AMENDMENT OF SOLICITATION/MODIFICATION OF CONTRACT			1. CONTRACT ID CODE	PAGE OF PAGES
2. AMENDMENT/MODIFICATION NO. 0001	3. EFFECTIVE DATE 14-Jun-2023	4. REQUISITION/PURCHASE REQ. NO.		5. PROJECT NO.(If applicable)

14. DESCRIPTION OF AMENDMENT/MODIFICATION (Organized by UCF section headings, including solicitation/contract subject matter where feasible.) The above numbered Solicitation for West Shore Lake Pontchartrain, Louisiana, Hurricane and Storm Damage Risk Reduction Project, Levees and I-10 West T-Wall Crossing, WSLP-106, St John the Baptist Parish, Louisiana has been amended to: a) Provide updated plans and specifications. b) Provide updated bid schedule. c) Provide answers to prior questions d) All questions are due NLT 11:00am CST on June 22, 2023 e) Bid submission date changed to June 29, 2023, at 10:30am CST				
Except as provided herein, all terms and conditions of the document referenced in Item 9A or 10A, as heretofore changed, remains unchanged and in full force and effect.				
15A. NAME AND TITLE OF SIGNER (Type or print)		16A. NAME AND TITLE OF CONTRACTING OFFICER (Type or print)		
		TEL:	EMAIL:

WSLP-106 PRE-BID QUESTIONS

SHEET IDENTIFICATION
C-204

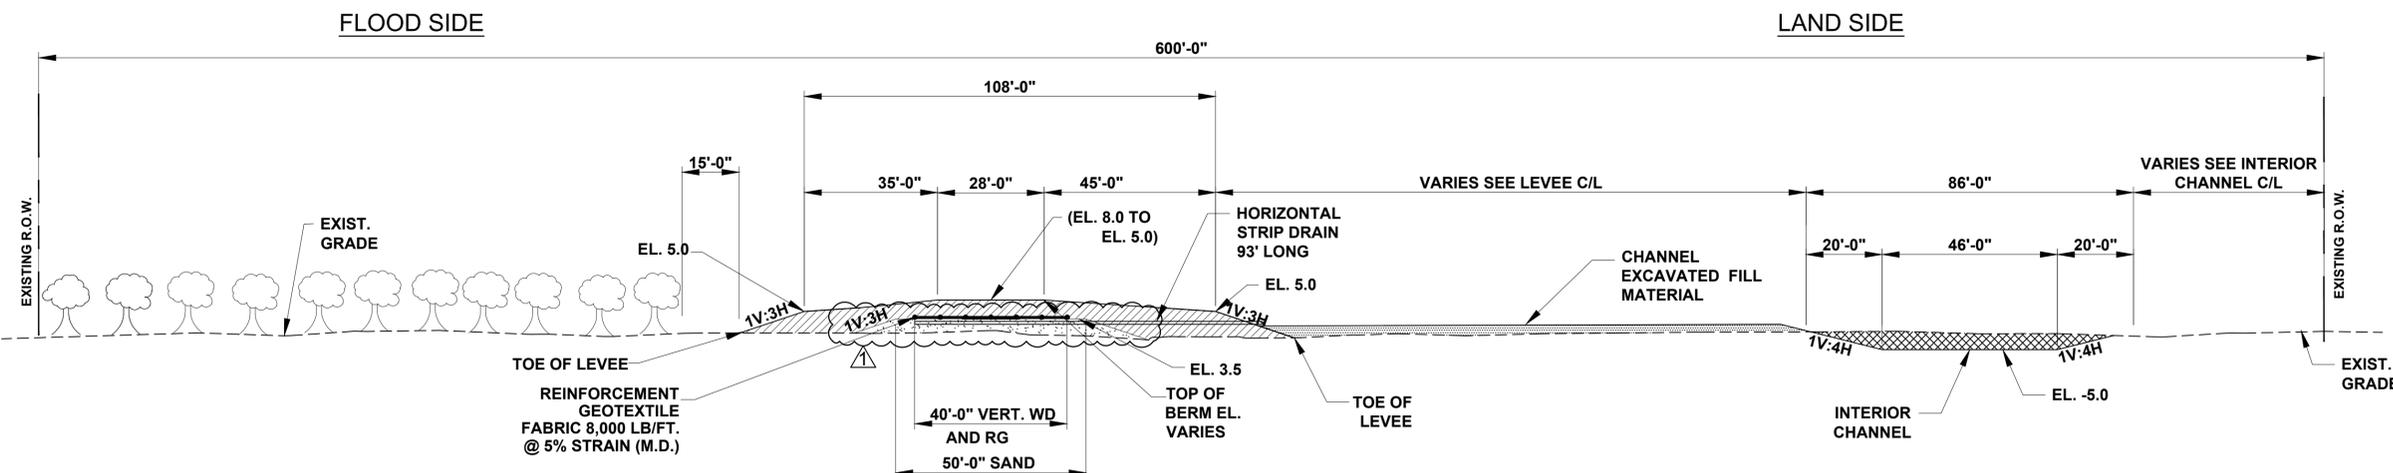
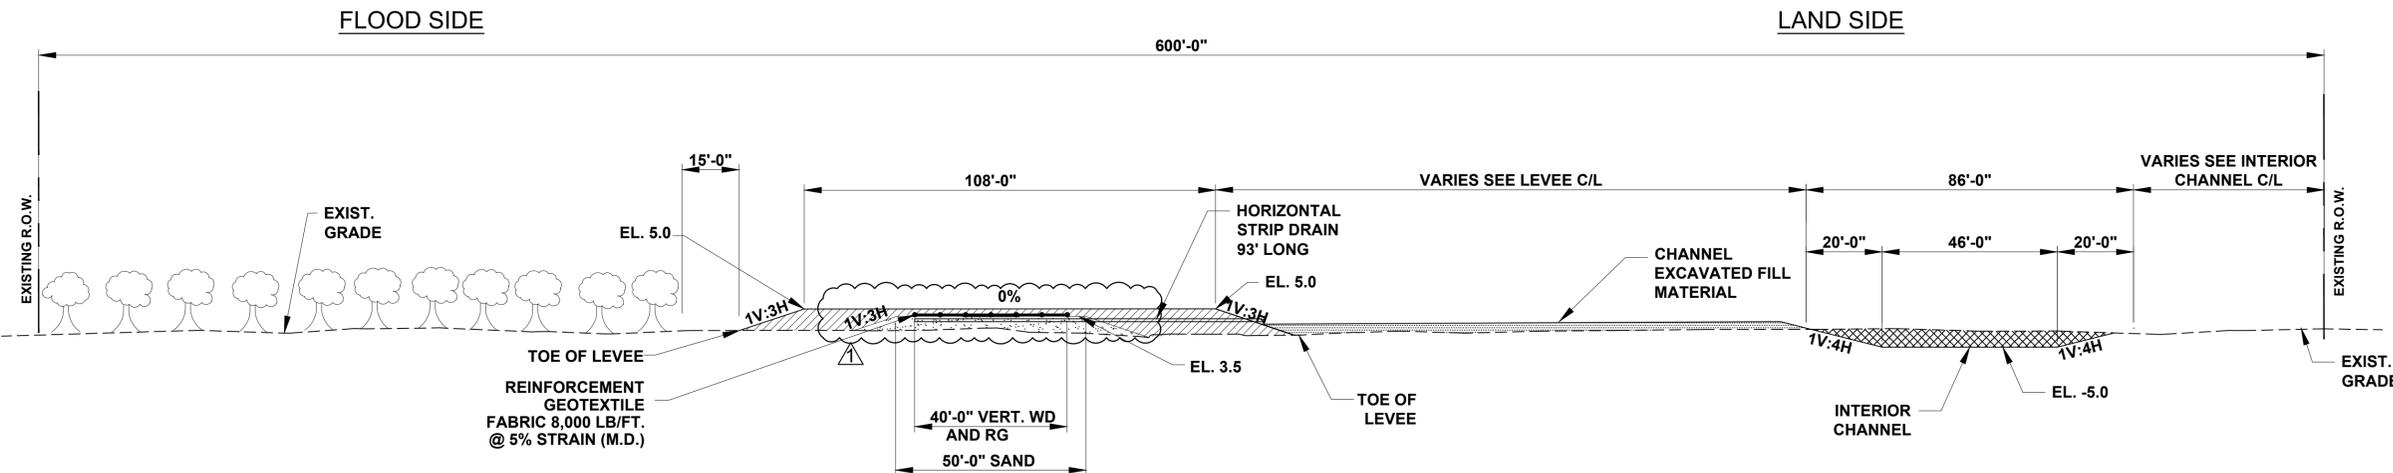
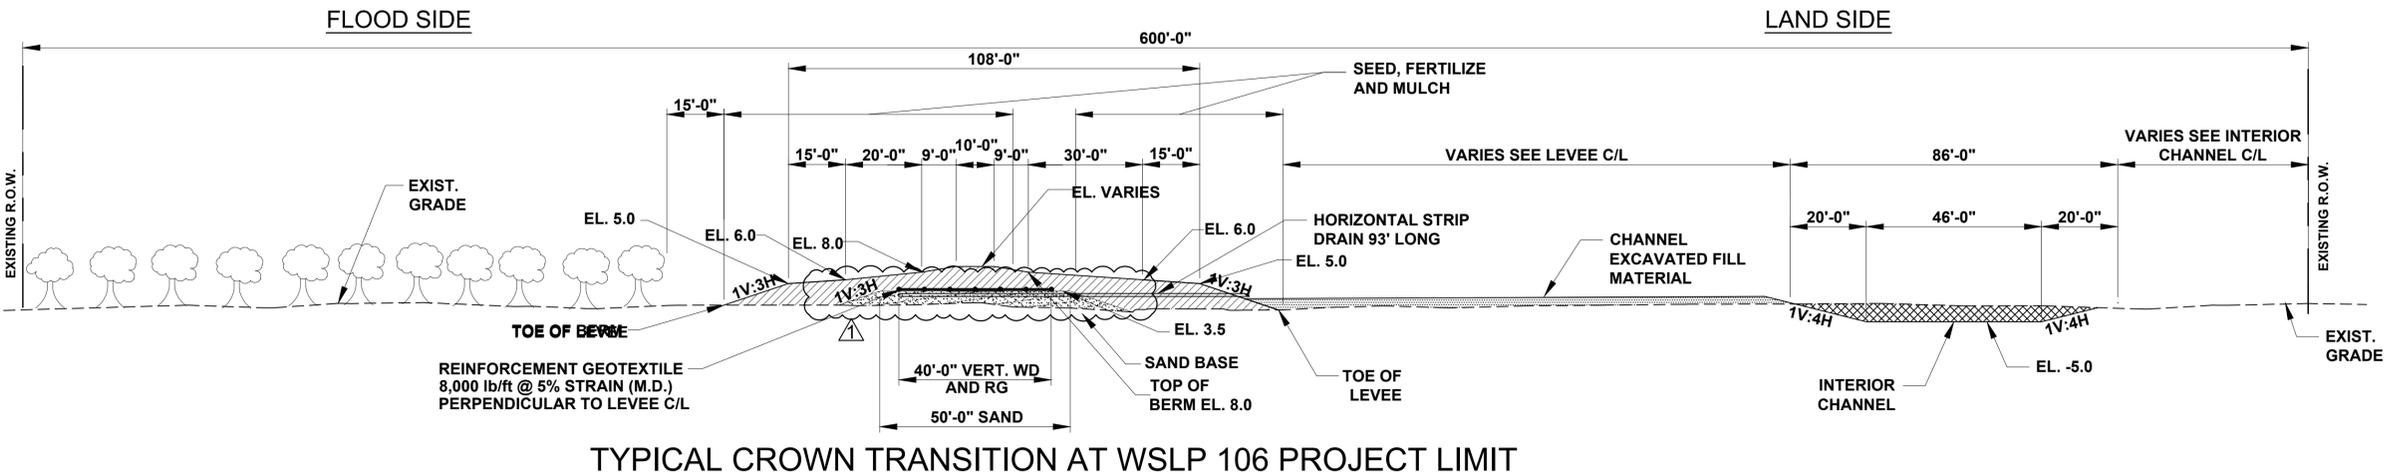
DATE	DESCRIPTION	MARK
6/6/2023	REVISE SAND BELOW EXISTING GRADE	Δ

SHEET IDENTIFICATION
C-211

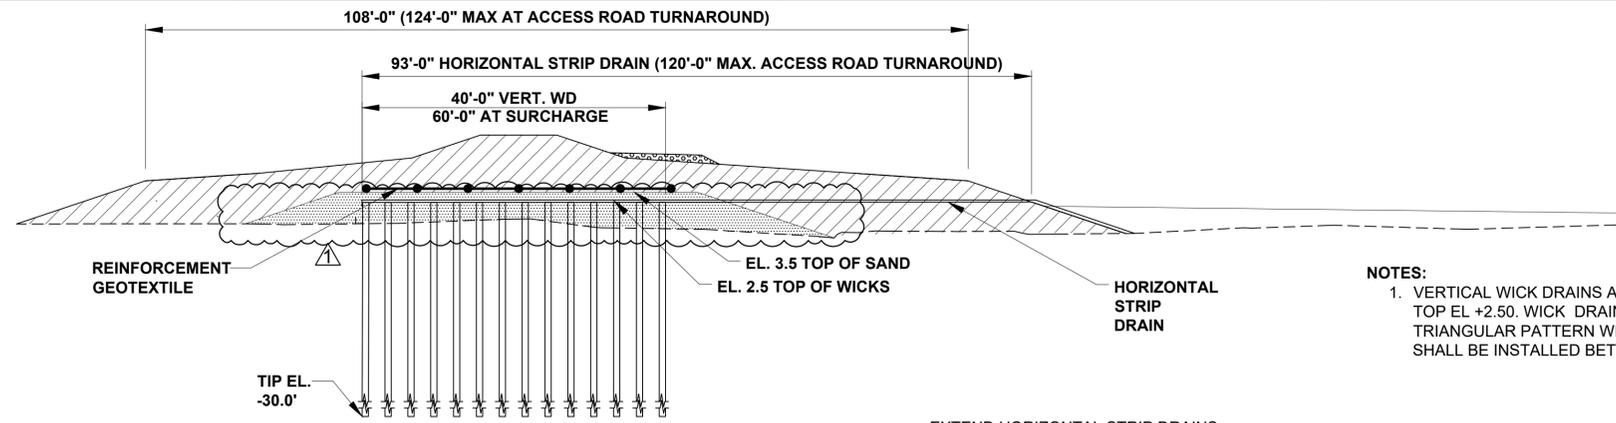
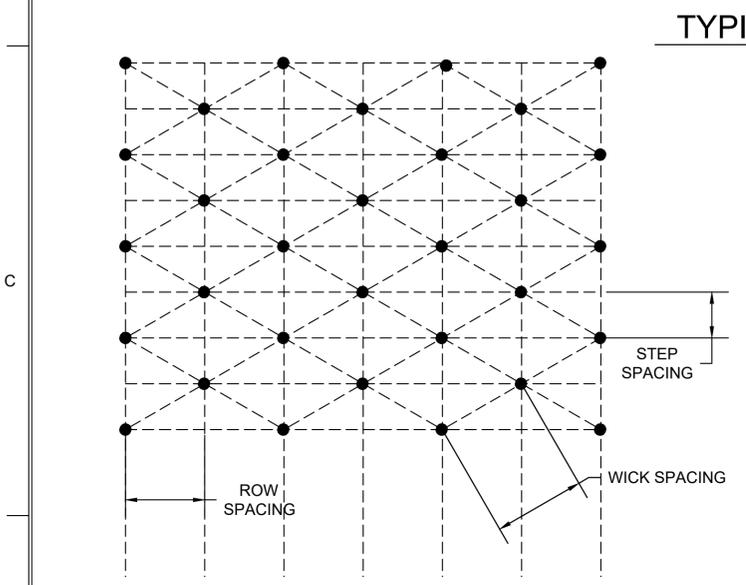
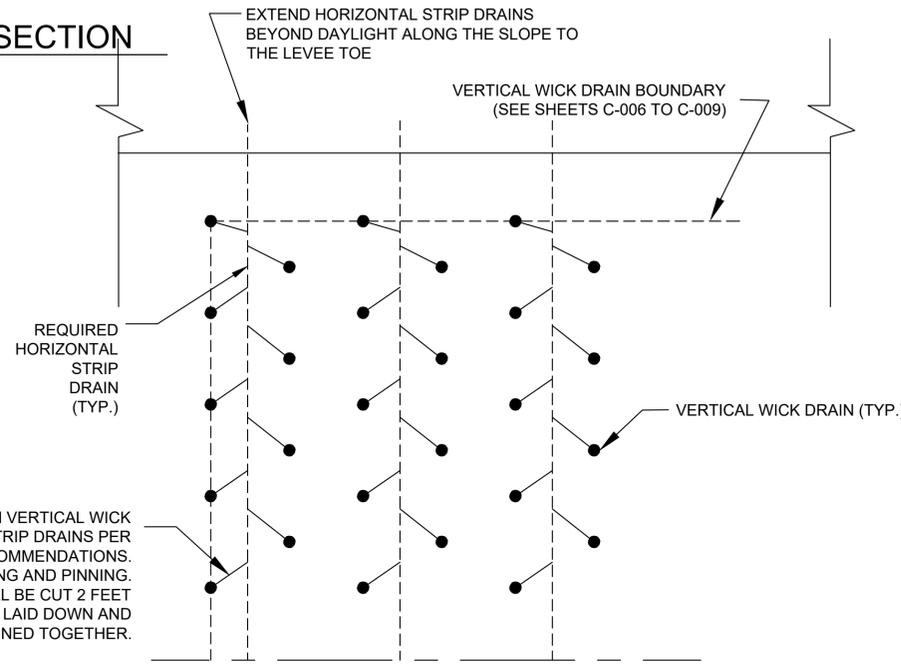
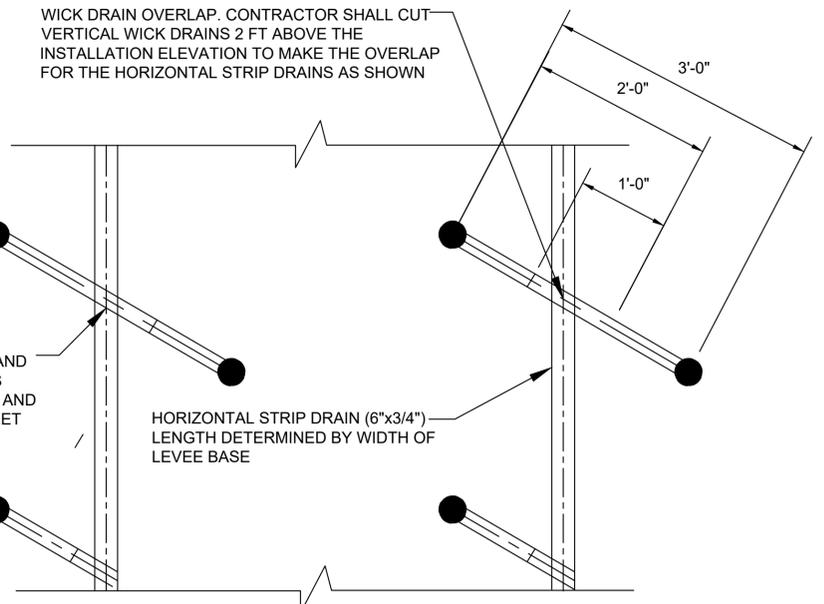
36. Drawing C-211 "Typical Full Levee Section" detail shows the wick drain tip elevation at -30.0. "Horizontal Strip Drain and Wick Drain Overlap Details (Plan View)" notes Vertical Wick Drain Installed to Tip at EL - 50.0. **El. -30.0 is correct for WSLP 106. Drawing to be revised by Amendment. This is addressed by Amendment 0001.**

DATE	DESCRIPTION	MARK	DATE	DESCRIPTION	MARK
8/1/2023	REVISE SAND AND WICK TIP EL. IN NOTE	Δ

NOTES:
 1. VERTICAL WICK DRAINS AND HORIZONTAL STRIP DRAINS ARE TO BE INSTALLED TO TOP EL +2.50. WICK DRAIN AREA SHALL CONTAIN VERTICAL WICKS IN A TRIANGULAR PATTERN WITH A 3 FOOT DRAIN SPACING. HORIZONTAL STRIP DRAINS SHALL BE INSTALLED BETWEEN THE ROWS OF VERTICAL WICK DRAINS.

CROSS SECTION
SHEET IDENTIFICATION
C-301

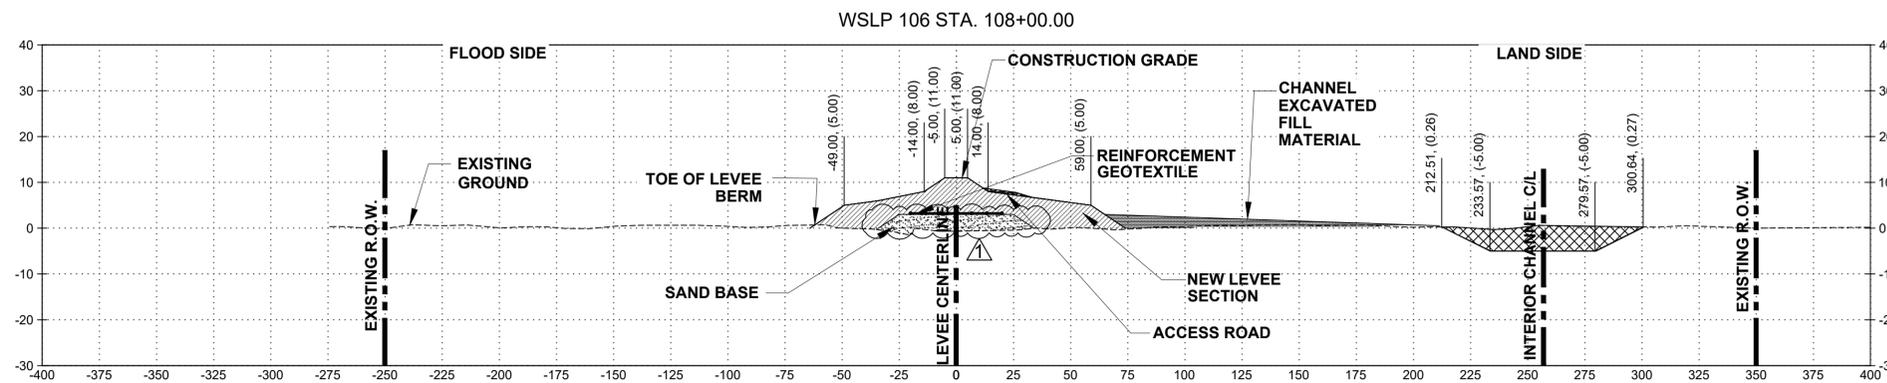
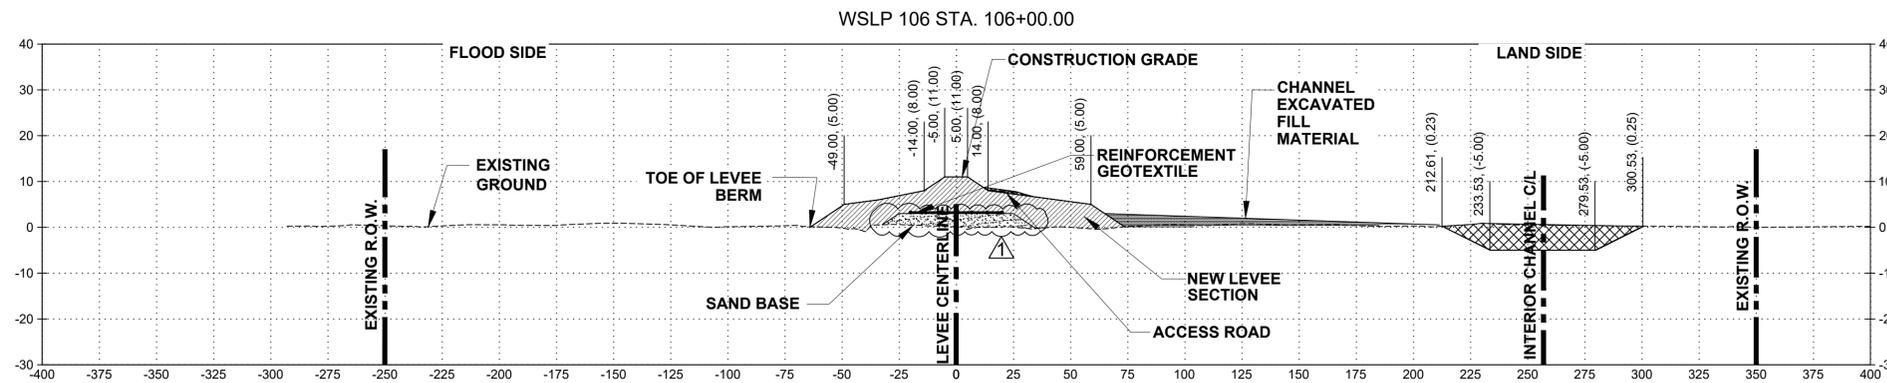
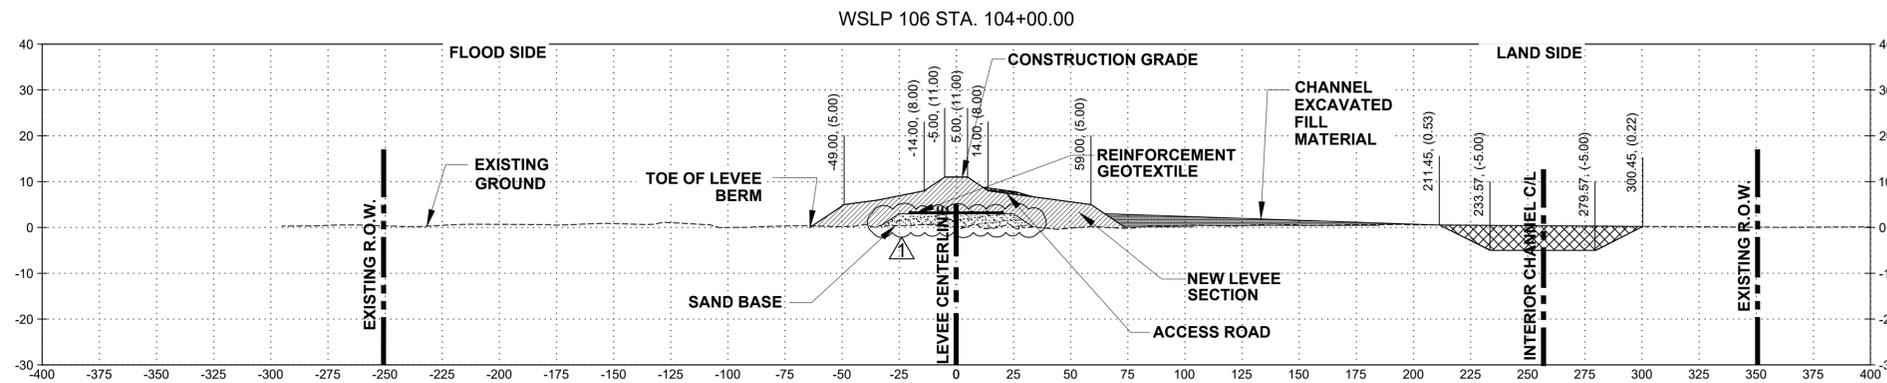
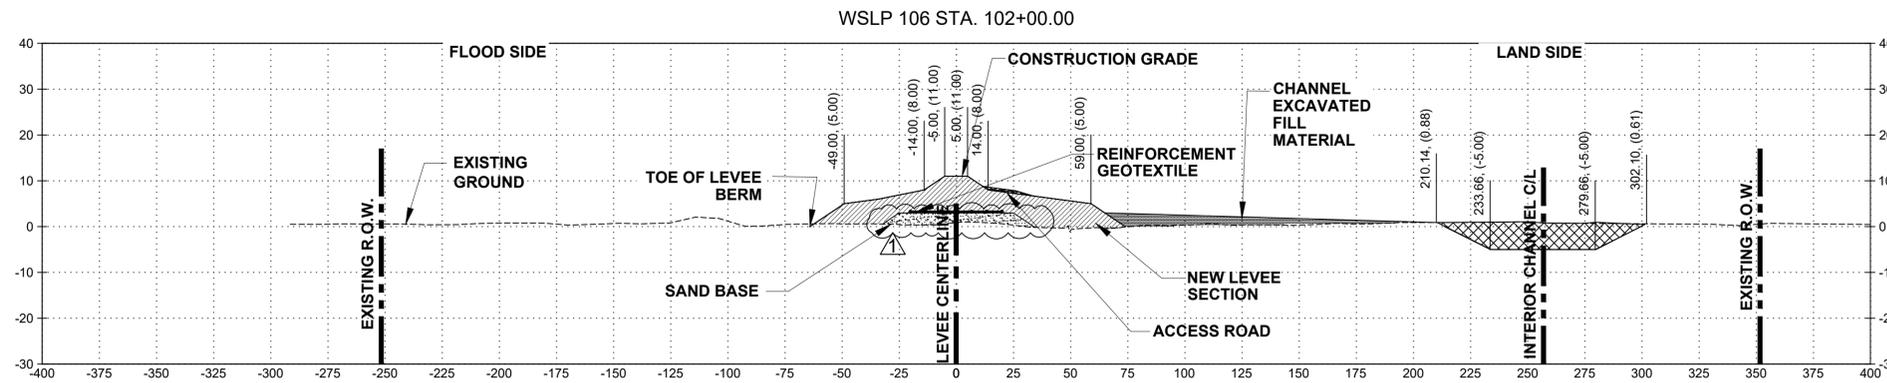
25. The cross sections on drawings C-301 thru C-306 depict the sand base and levee embankment being placed below the existing ground line. Is the Government's intent to excavate to these template lines and grades prior to placing the sand base and levee embankment? **No. Cross Sections shall be revised by Amendment. This is addressed by Amendment 0001.**

DATE	DESCRIPTION	APPR.
6/6/2023	REVISE SAND BELOW EXISTING GRADE	K.K.

- If this area is to be excavated, can the material be spread onsite? **This area is not to be excavated and will be clarified by Amendment. This is addressed by Amendment 0001.**

- Will this material be measured for payment from the template line shown on Drawings C-301 thru C-306? **This area is not to be excavated and will be clarified by Amendment. This is addressed by Amendment 0001.**
